CALL NO. 304
CONTRACT ID NO. 171048
ADDENDUM # 1

Subject: Hopkins County, FD04 SPP 054 041A 000-002
Letting December 8, 2017

- (1) Revised - Note -Page 22 of 201
- (2) Revised - Special Note -Page 27 of 201
- (3) Revised - Bid Items -Pages 197-201 of 201
- (4) Added - Sheets -Pages 1-93 of 93
- (5) Revised - Plans -Pages R2j, R2k, T9, T16A, T17A, T17, U92 and U93

POLE LOCATIONS		
POLE	STATION	OFFSET
POLE "A"	706+73.11	72.28 RT
POLE "B"	705+10.47	51.54 RT
POLE "C"	705+45.32	68.34 LT
POLE "D"	707+03.96	73.17 LT

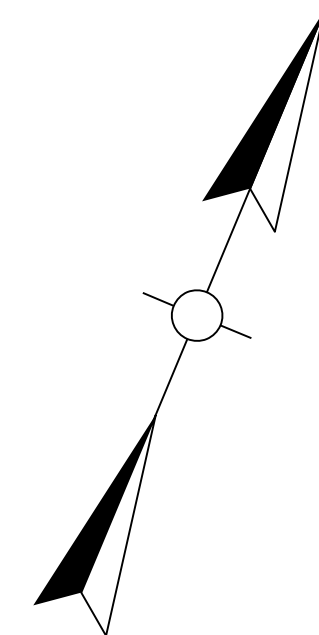
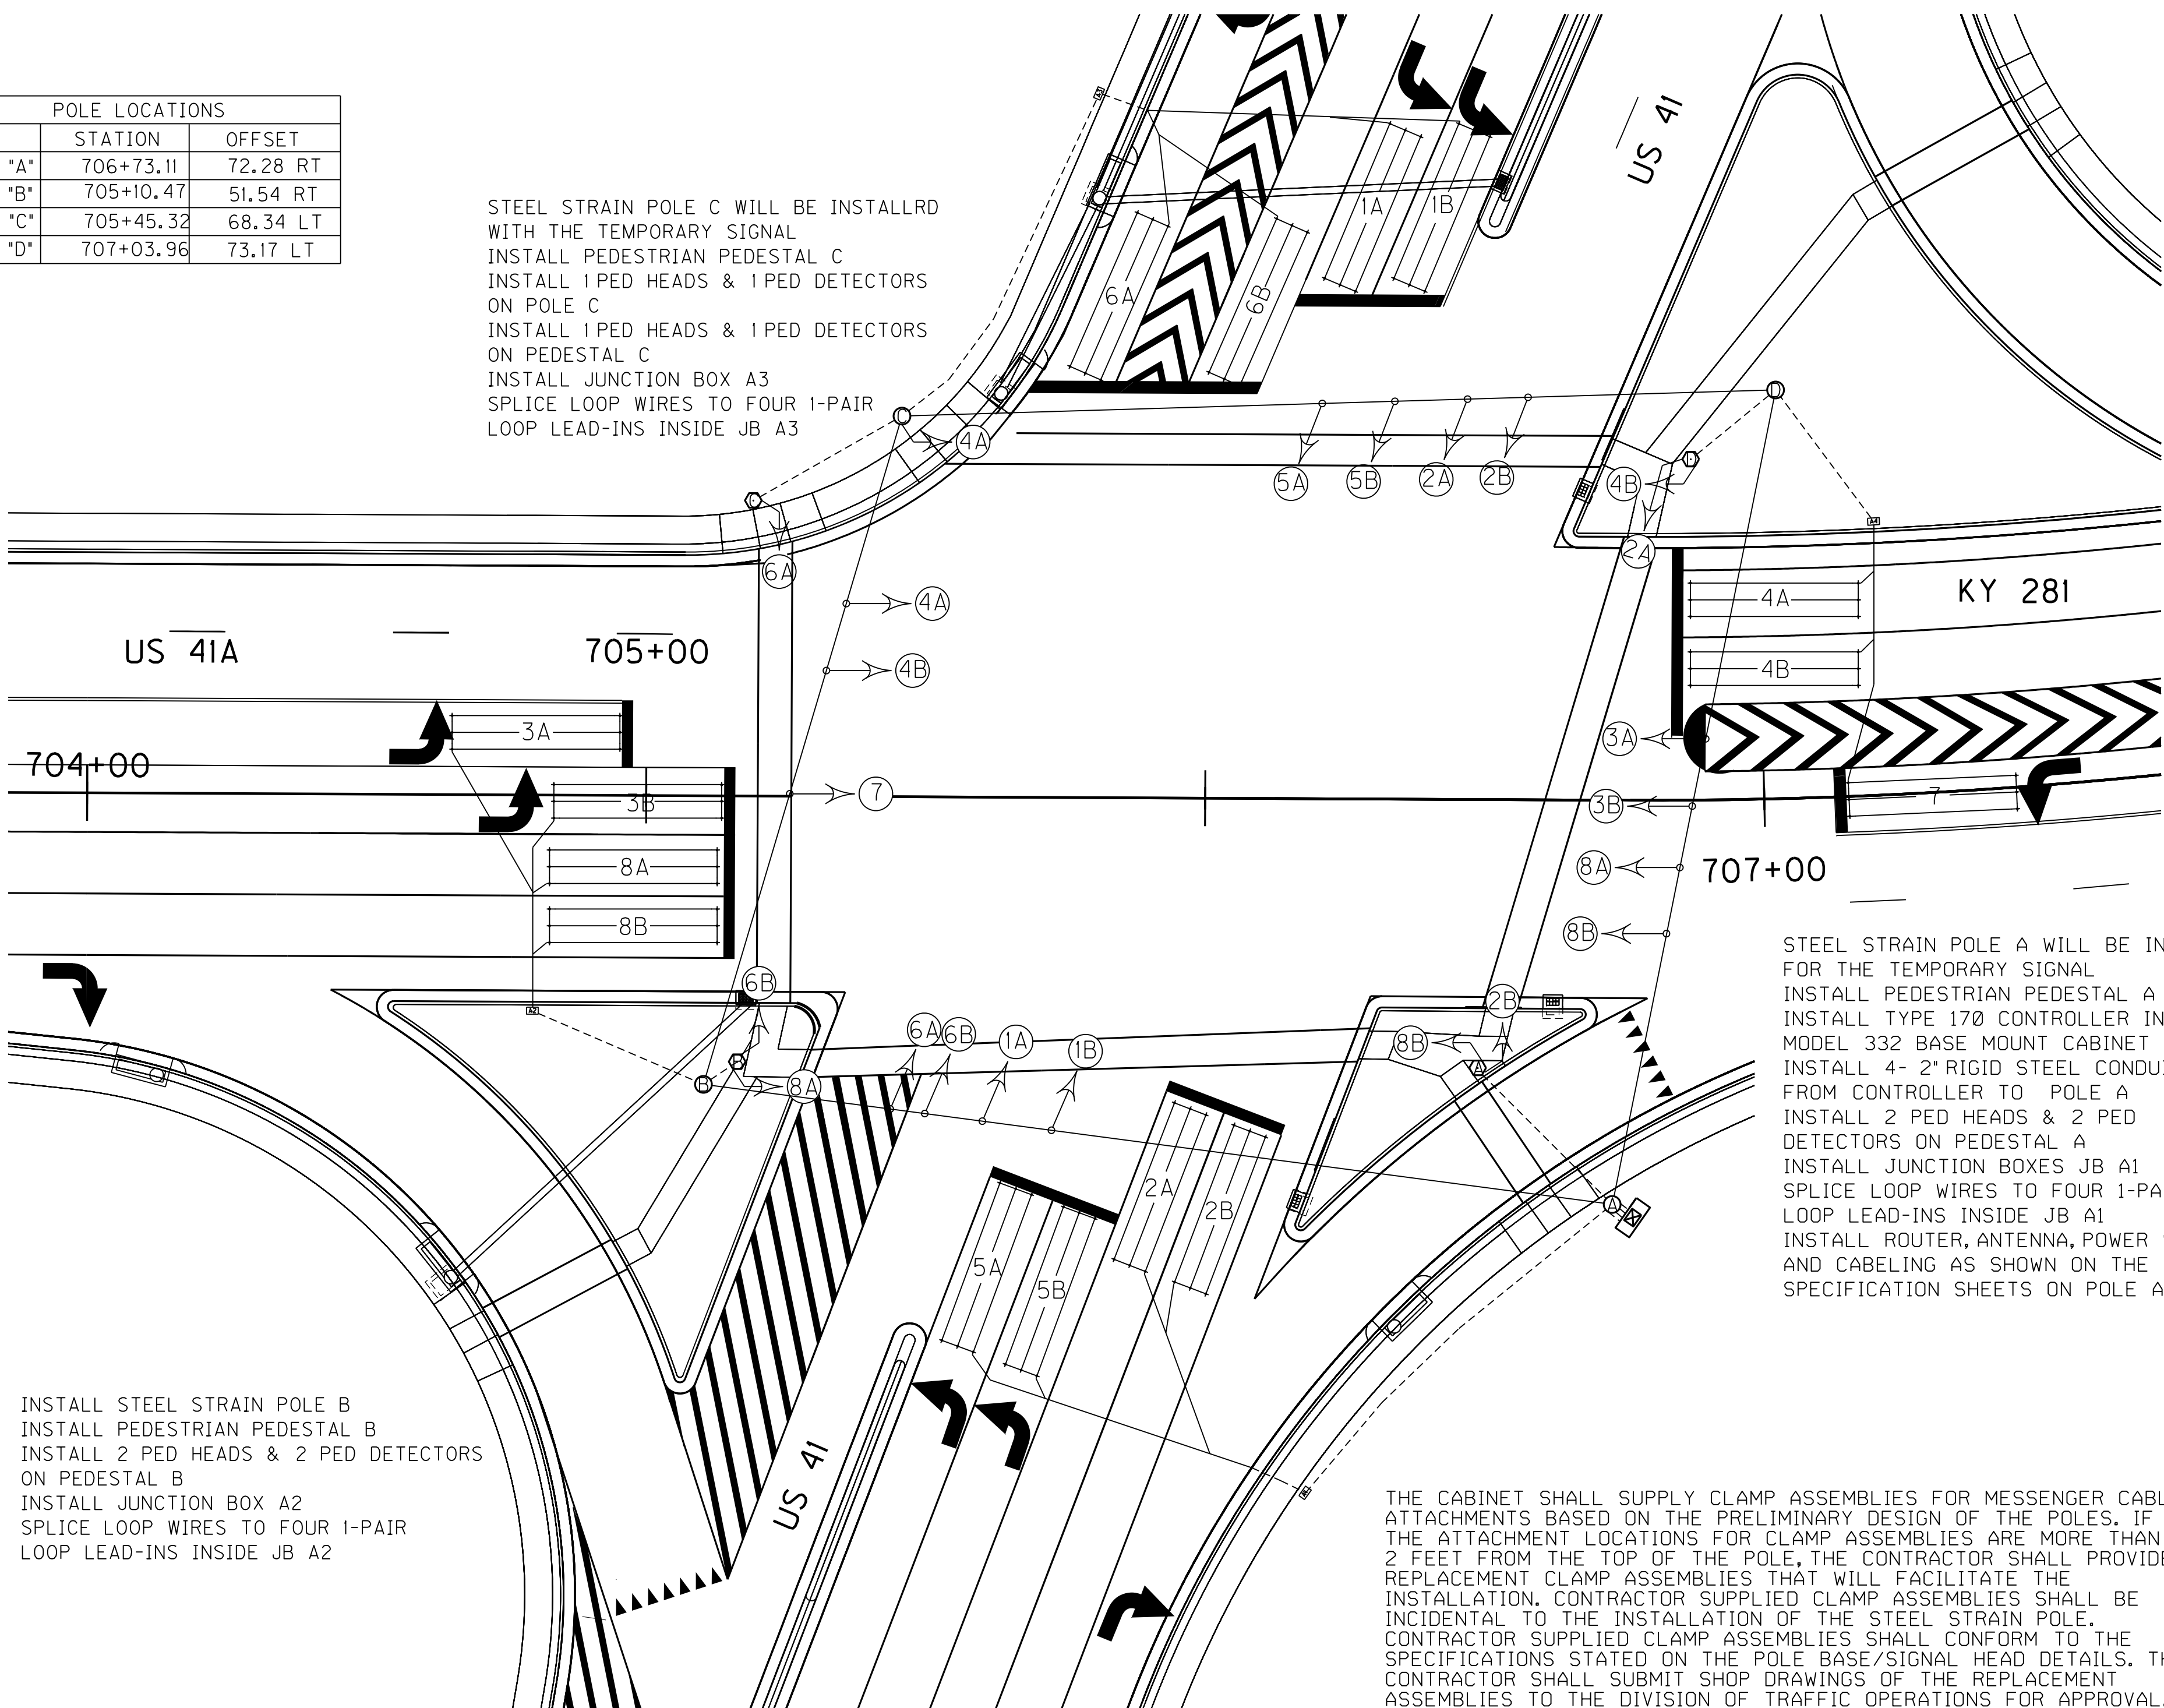
REVISED 11-30-2017

STEEL STRAIN POLE C WILL BE INSTALLED WITH THE TEMPORARY SIGNAL
INSTALL PEDESTRIAN PEDESTAL C
INSTALL 1 PED HEADS & 1 PED DETECTORS ON POLE C
INSTALL 1 PED HEADS & 1 PED DETECTORS ON PEDESTAL C
INSTALL JUNCTION BOX A3
SPlice LOOP WIRES TO FOUR 1-PAIR LOOP LEAD-INS INSIDE JB A3
